Addendum / Addenda

No./N^o
2

Project Description / Description de projet M10-Electrical Vault Ventilation		
Solicitation No./ No de sollicitation 14-22068	Project No./N ^o de projet 4021	W.O. No./N ^o d'ordre de travail A1-004018-02
Project Engineer / Ingénieur de projet Josh Hale (Stantec)		Date November 12,2014
<p>Notice: This addendum shall form part of the tender documents and all conditions shall apply and be read in conjunction with the original plans and specifications.</p>		<p>Nota: Cet addenda fait partie intégrale des dossiers d'appel d'offres; toutes les conditions énoncées doivent être lues et appliquées en conjonction avec les plans et les devis originaux.</p>

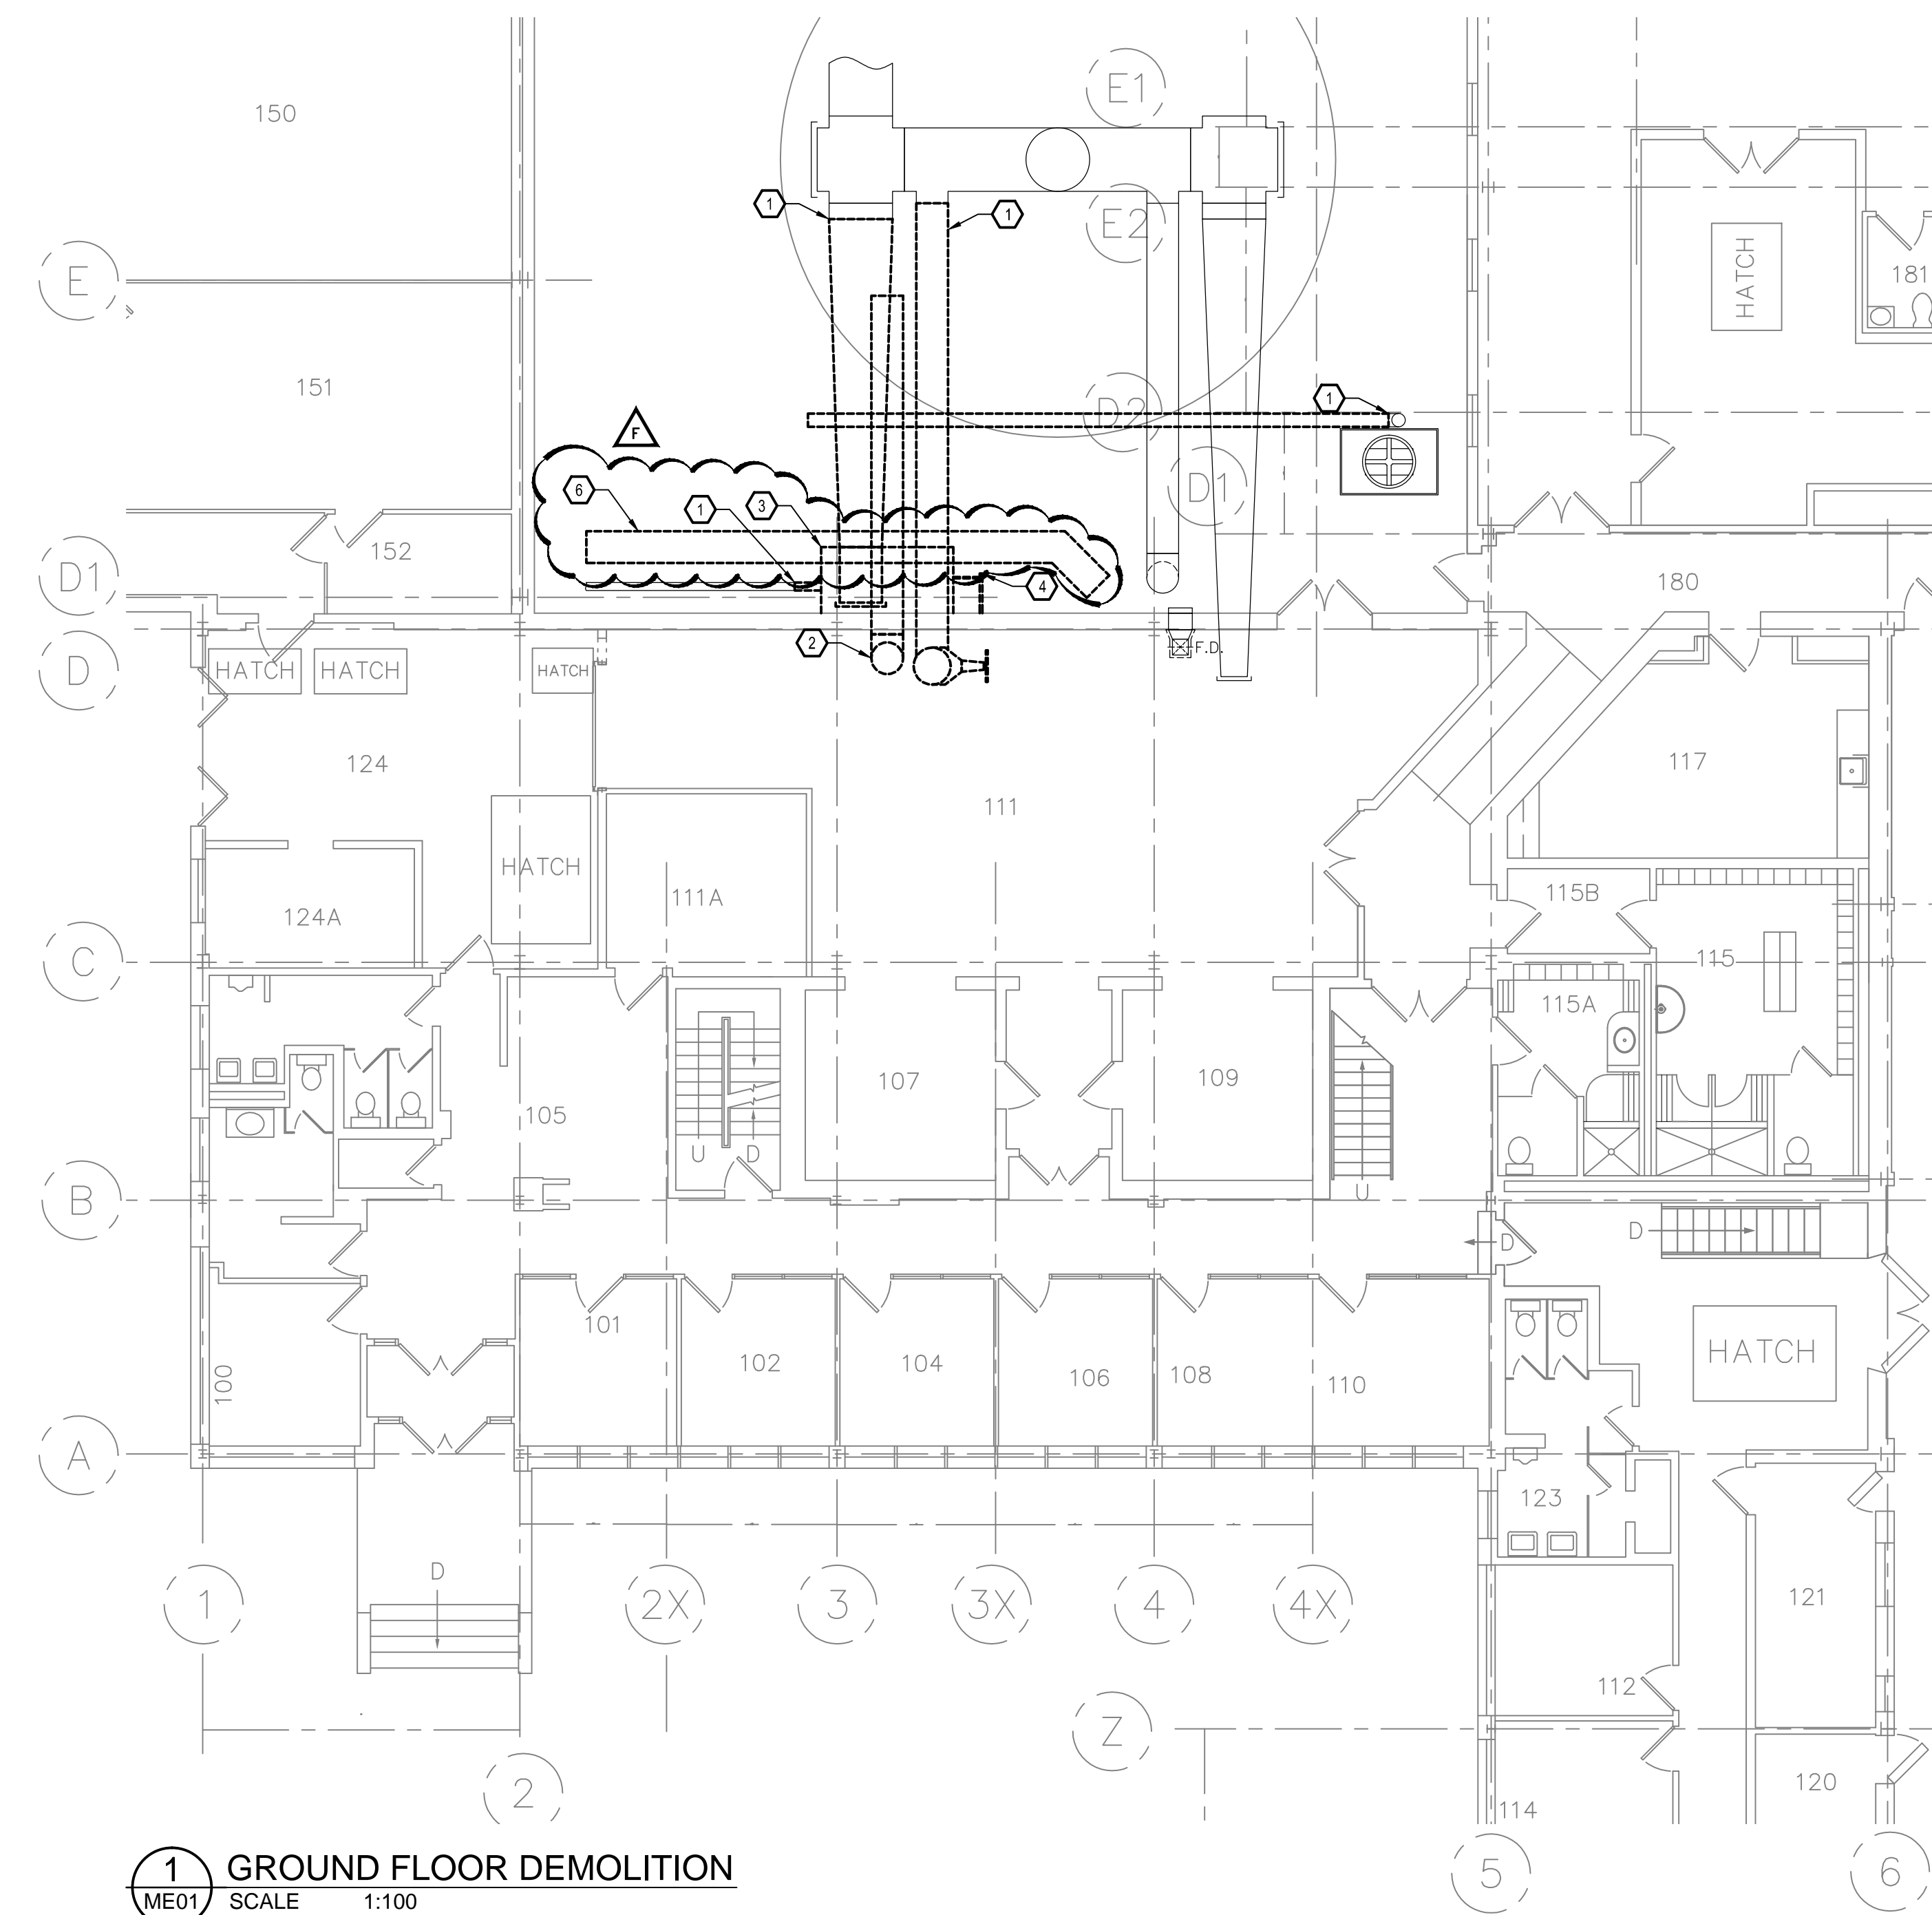
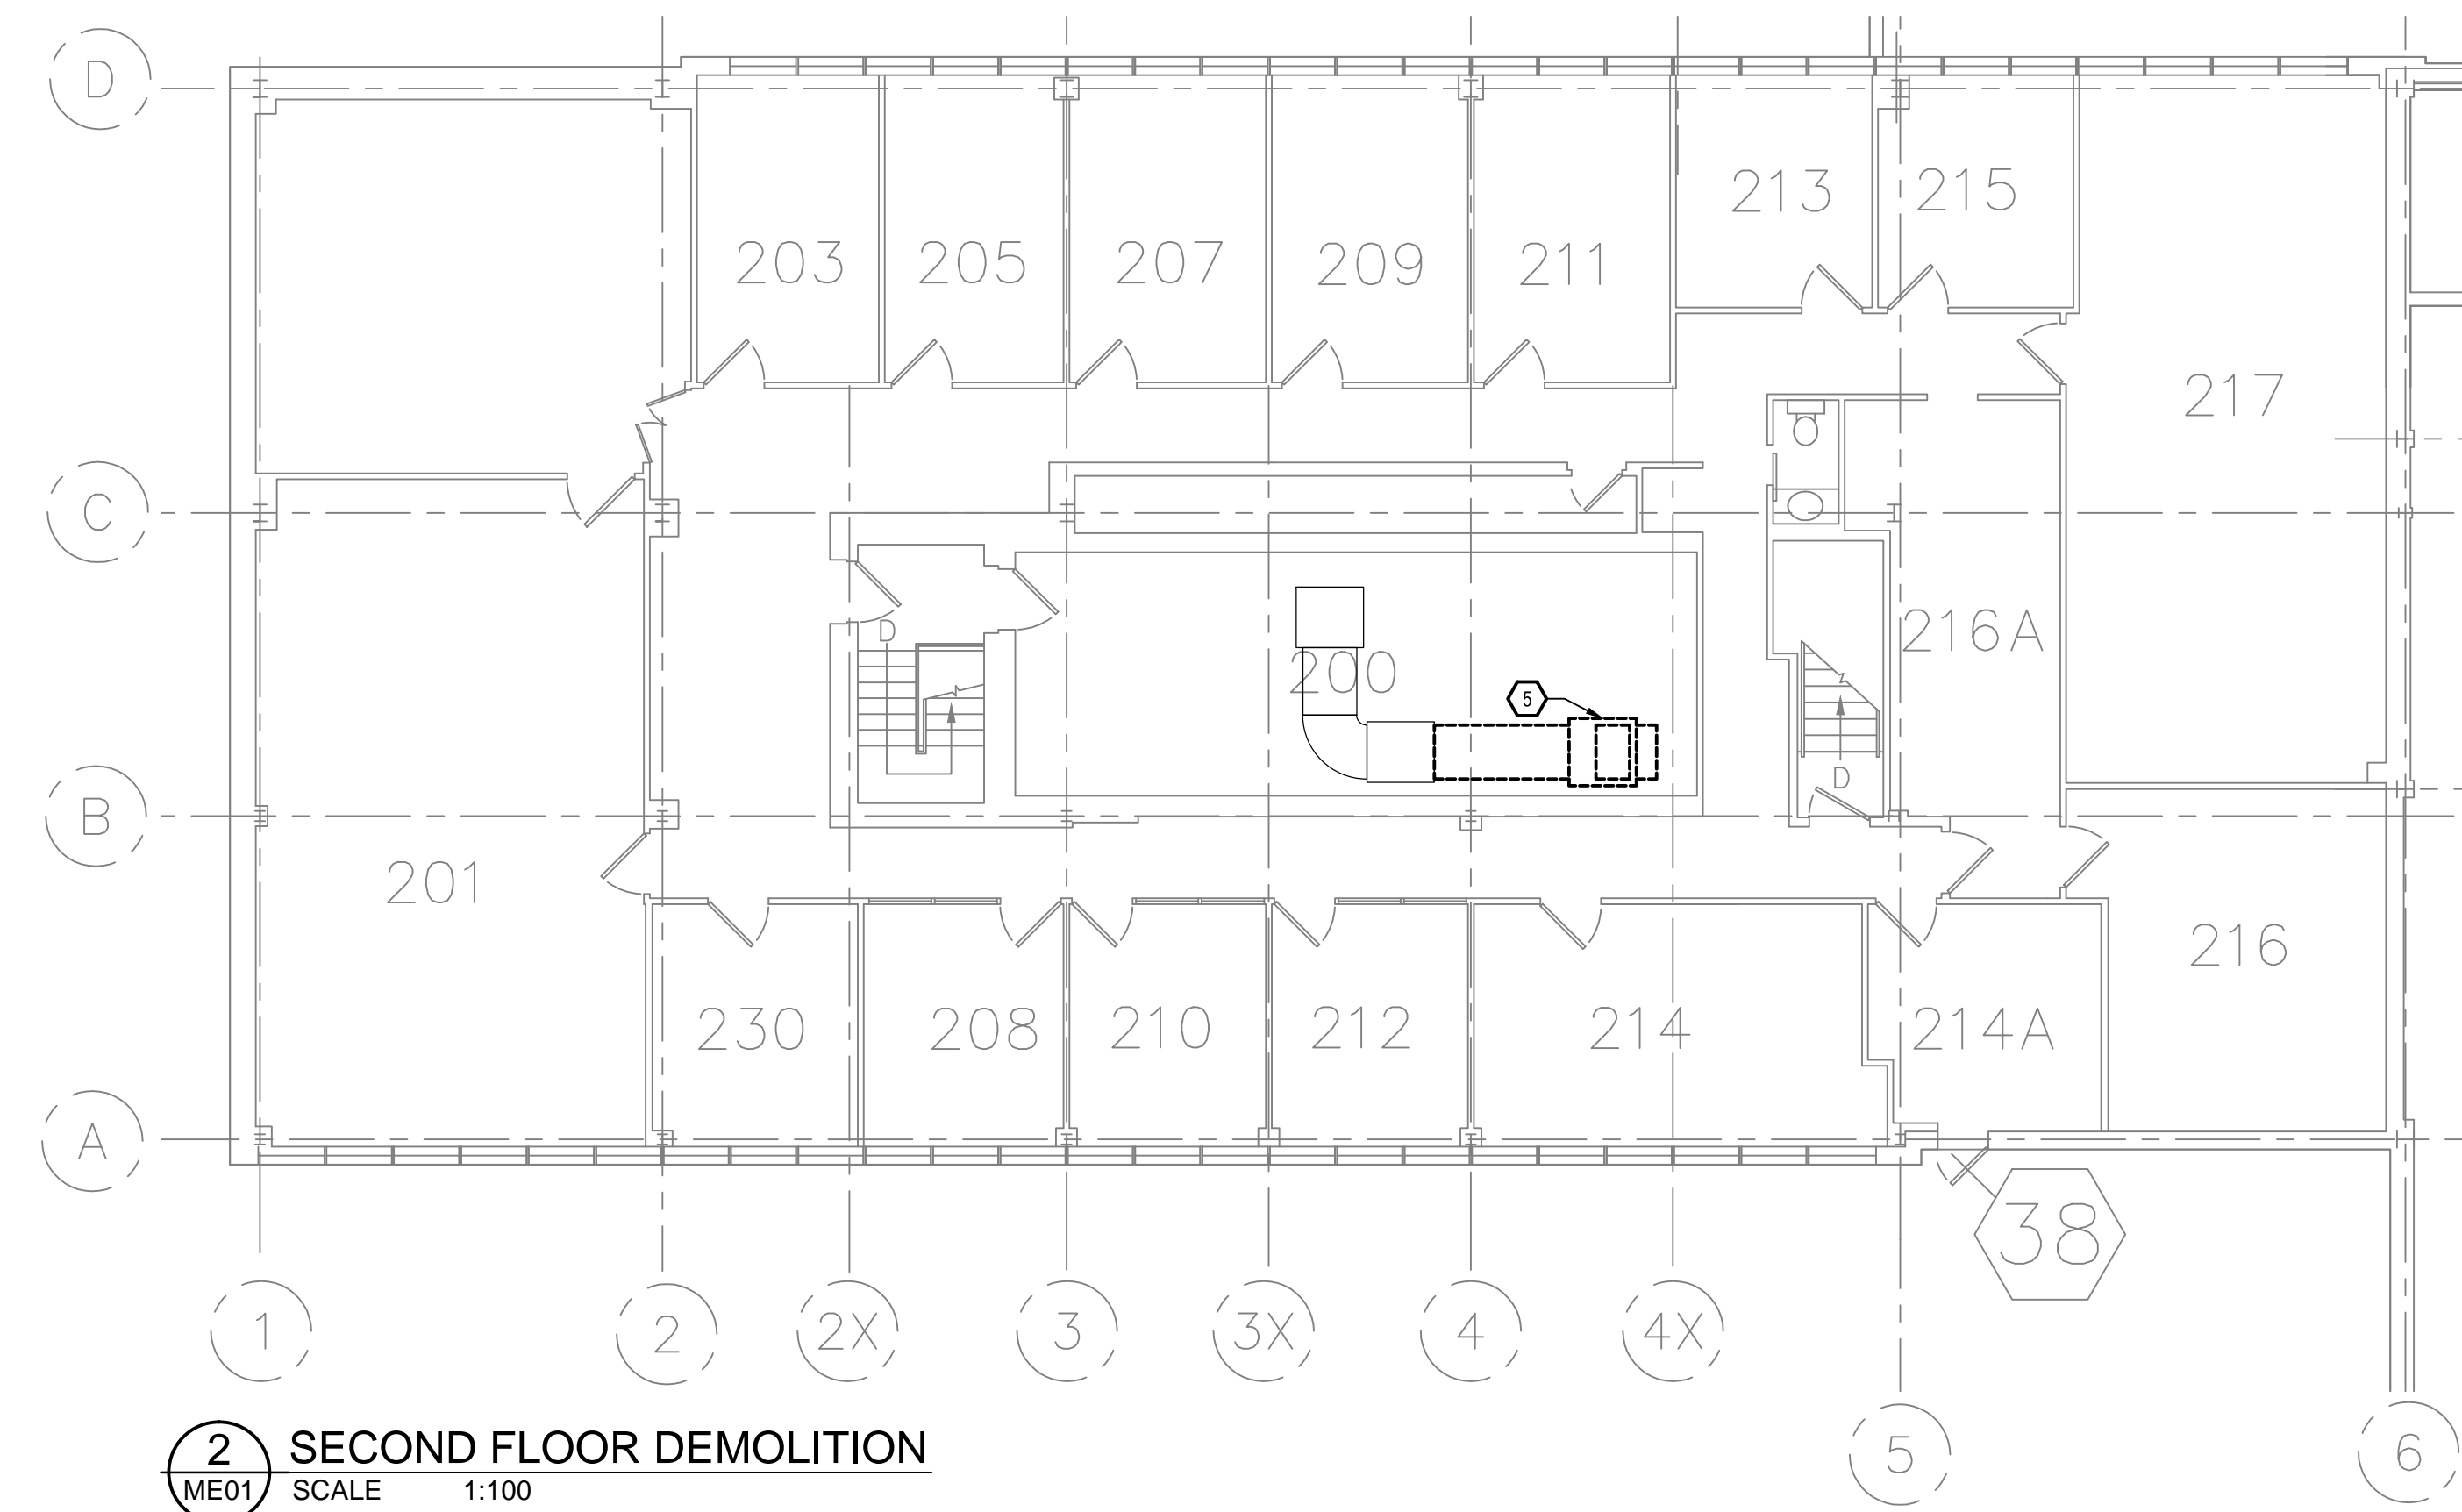
2. Drawings ME02 have been updated to show correct location of PD6
3. Drawings ME03 have been updated to show correct location of VFD, (Fan F-1) VSD to be installed inside room 200 below mezzanine.
4. Drawings ME01 have been updated to show location of piping under new backfill .

3 EXTERIOR PIPING REMOVAL DETAIL
 ME01 SCALE N.T.S.

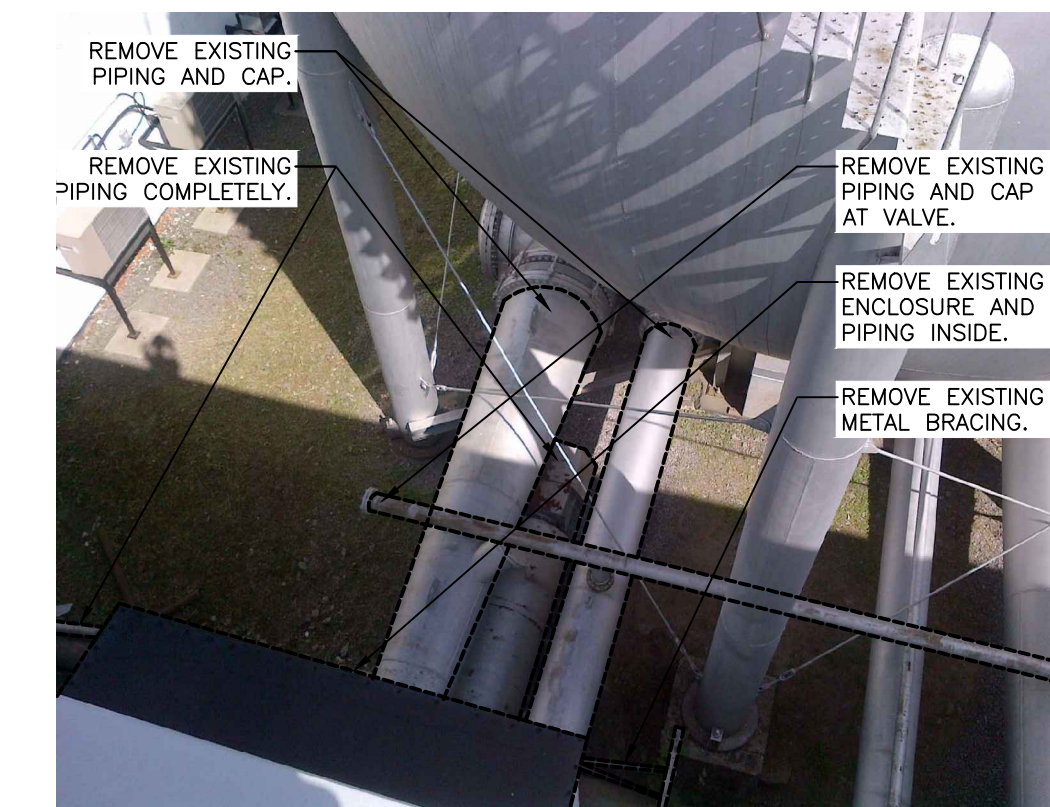
- i) Above ground pipes on detail 3/ME01 bolted on cap with gasket and matching finish or tack weld square plate primed paint only.

- ii) In the ground pipe at bottom of trench, tack weld on 3 sides with square primed plate. Please confirm both installations.

Answer: Bolt on cap to be used with gasket to match existing. Drawing notes have been updated.

Answer: Pipes to be capped and completely sealed. Drawing notes have been updated .

1. ABOVE GROUND PIPES ON DETAIL 3/ME01 SHALL BE CAPPED WITH BOLTED ON CAP WITH GASKET AND MATCHING FINISH.
2. IN GROUND PIPE AT BOTTOM OF TRENCH SHALL BE CAPPED WITH SQUARE PRIMED PLATE, WELDED COMPLETELY SEALED.
